Access Compliance Report

Public Rights-of-Way

(Curb Ramps)

Intersection ID: 45242	Main Street: TALUS_TRACE_LN	Cross Street: KODIAK_CT	Location: SW
ADA ID: EB3526EAB72E	Ramp Type: PerpDiag	Initial Pass/Fail: Fail	Overall Compliance: No
			Severity Score: 13.75

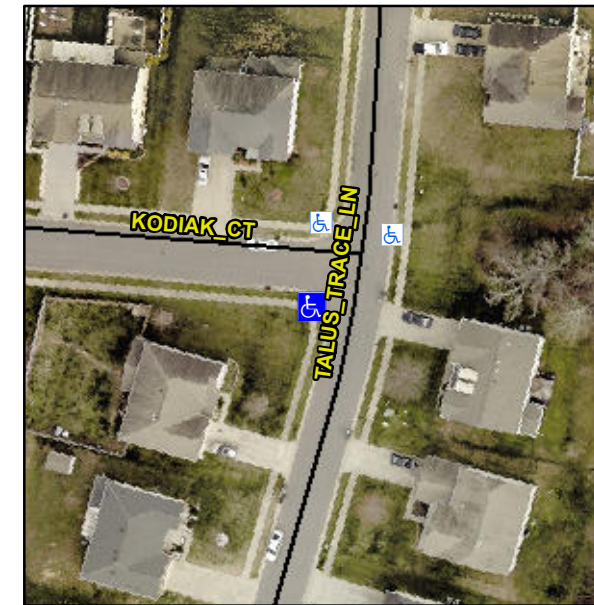
Not Found, R304.2.2, R304.5.3

Compliance	Description	Data	Compliance	Description	Data
N/A	Ramp Length (in)	49.0	No	Ramp Slope (%)	9.9
Yes	Ramp Width (in)	48.0	No	Ramp XSlope (%)	4.1
N/A	Flare Type LT	N/A	N/A	Flare Type RT	N/A
N/A	Flare Slope LT (%)	N/A	N/A	Flare Slope RT (%)	N/A
N/A	Flare Traversable LT?	N/A	N/A	Flare Traversable RT?	N/A
N/A	Landing Length (in)	N/A	N/A	DWS Provided?	N/A
N/A	Landing Width (in)	N/A	N/A	DWS Contrast?	N/A
N/A	Landing Slope (%)	N/A	N/A	DWS Length (in)	N/A
N/A	Landing X Slope (%)	N/A	N/A	DWS Full Width?	N/A
N/A	Landing Curb? (Y/N)	N/A	N/A	DWS Offset (in)	N/A
N/A	Shared Landing?	N/A			
N/A	Gutter Ponding?	N/A	N/A	Gutter Slope (%)	N/A
N/A	Gutter Lip Ht (in)	N/A	N/A	Gutter X Slope (%)	N/A
N/A	Painted X Walk1?	No	N/A	Painted X Walk2?	No
	X Walk 1 Direction	To E		X Walk 2 Direction	To N
N/A	X Walk 1 Width (in)	N/A	N/A	X Walk 2 Width (in)	N/A
	X Walk 1 Slope (%)	0.7		X Walk 2 Slope (%)	1.4
	X Walk 1 X Slope (%)	1.0		X Walk 2 X Slope (%)	3.6

Remove & Replace Curb Ramp With Two New Directional Ramps or Equivalent.
